U.S. NUCLEAR REGULATORY COMMISSION

Report No. 50-346/82-01(DEPOS)

Facility Name: Davis-Besse, Unit 1

Emergency Preparedness Appraisal on February 8-19, 1982 (Report No. 50-346/82-01(DEPOS))

FIGURE 2.1

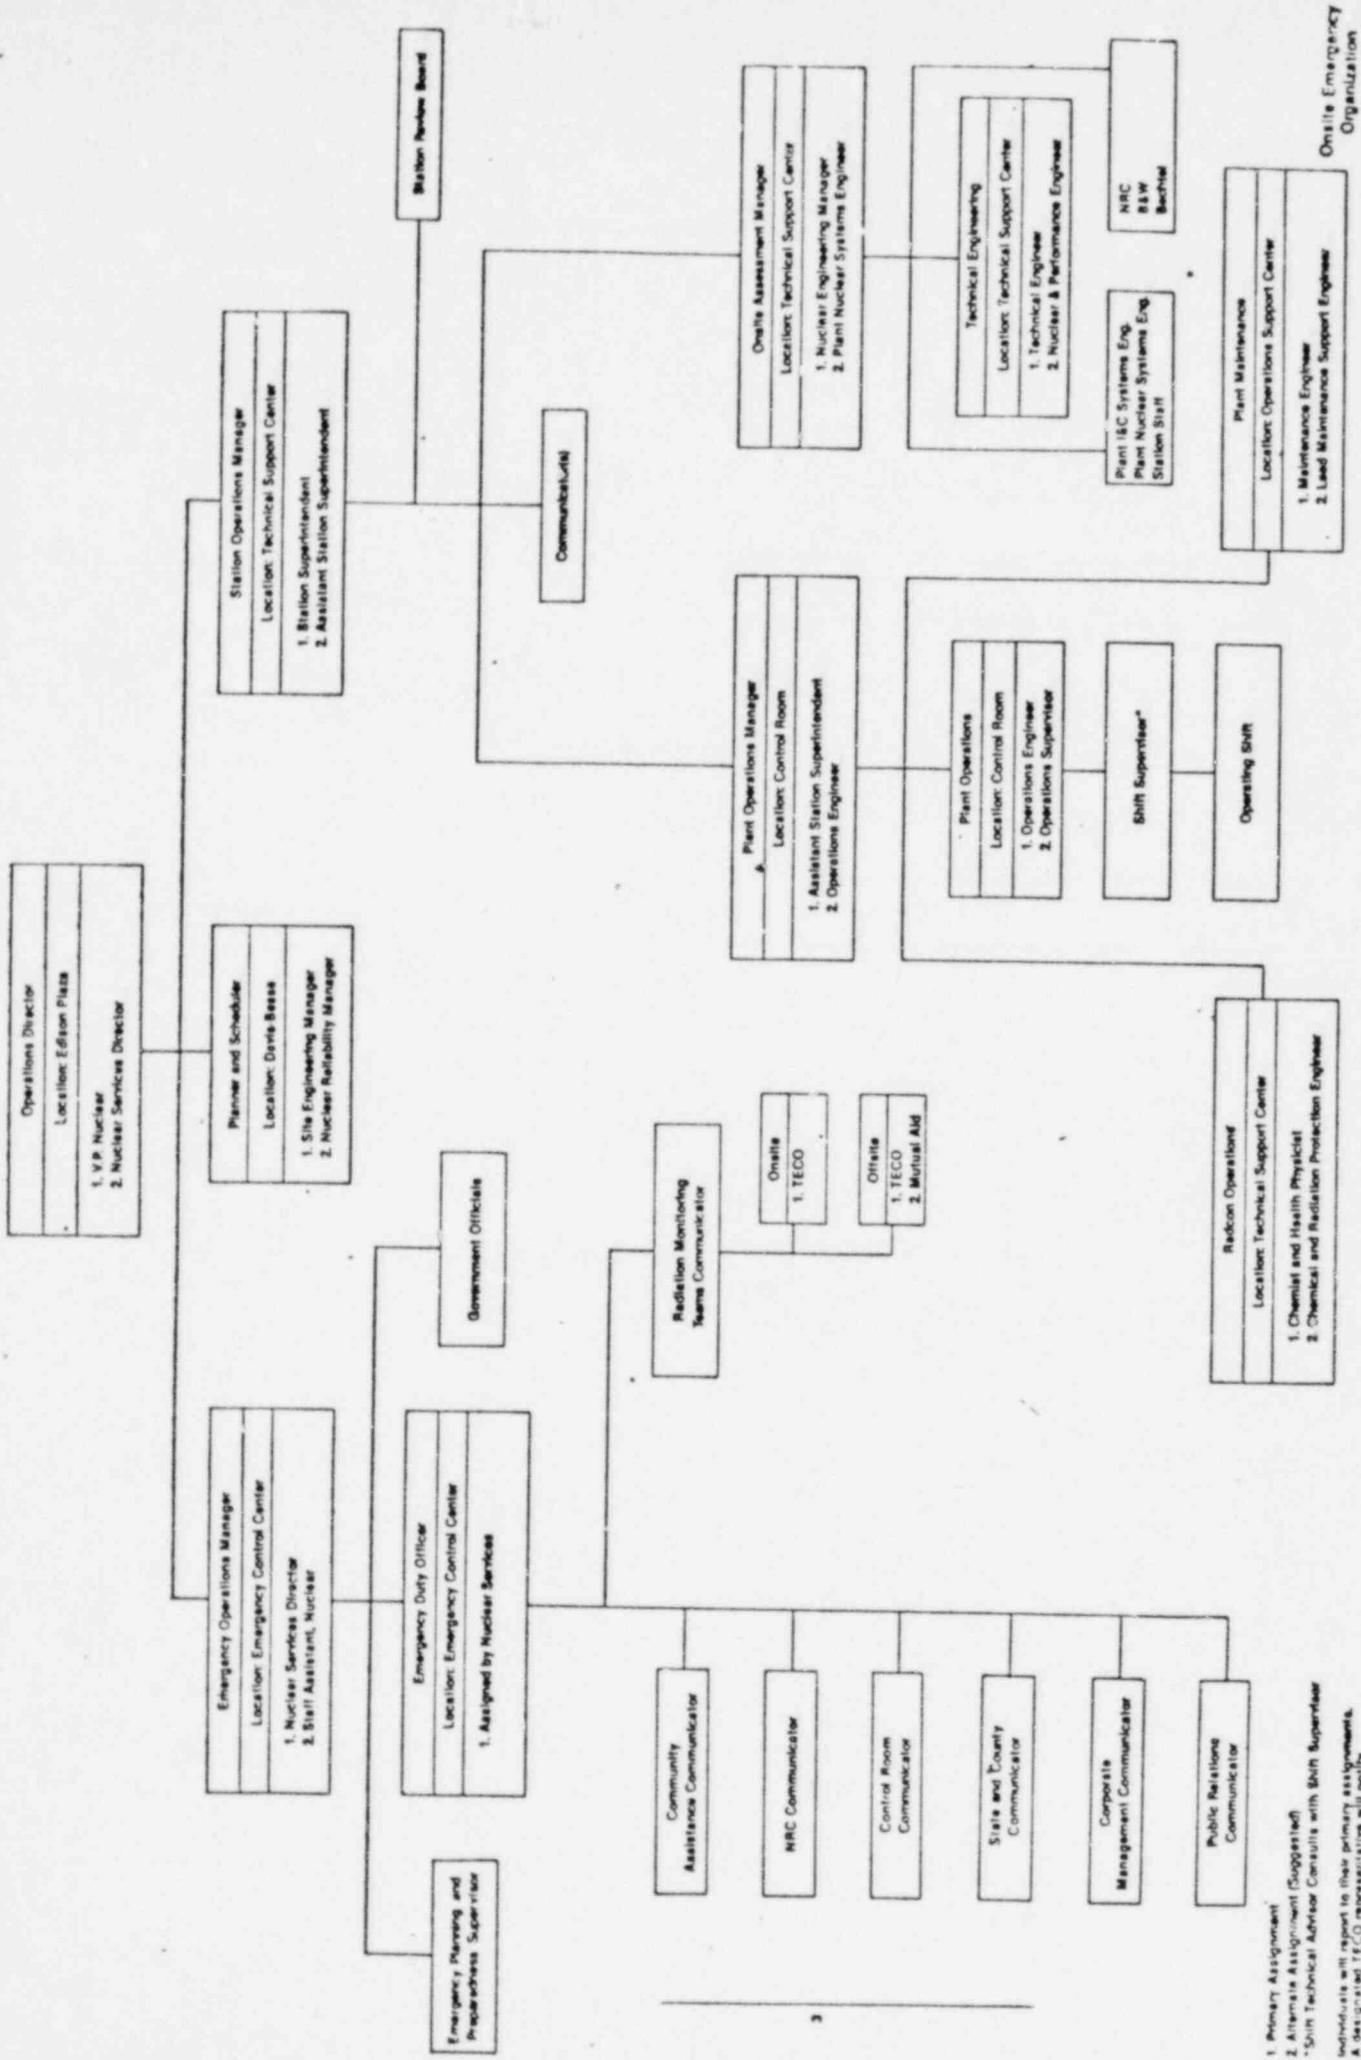
- . In Figure 5-3, of the Emergency Plan, Onsite Emergency Organization, change the location indicated for the Operations Director from Edison Plaza to Emergency Control Center.
- . In Section 5.2.2.1 of the Emergency Plan, revise the description of responsibilities for the Plant Operations Manager and the Operations Engineer to reflect a concept of supporting and advising the Shift Supervisor so that no confusion exists regarding who is in charge of control room activities.
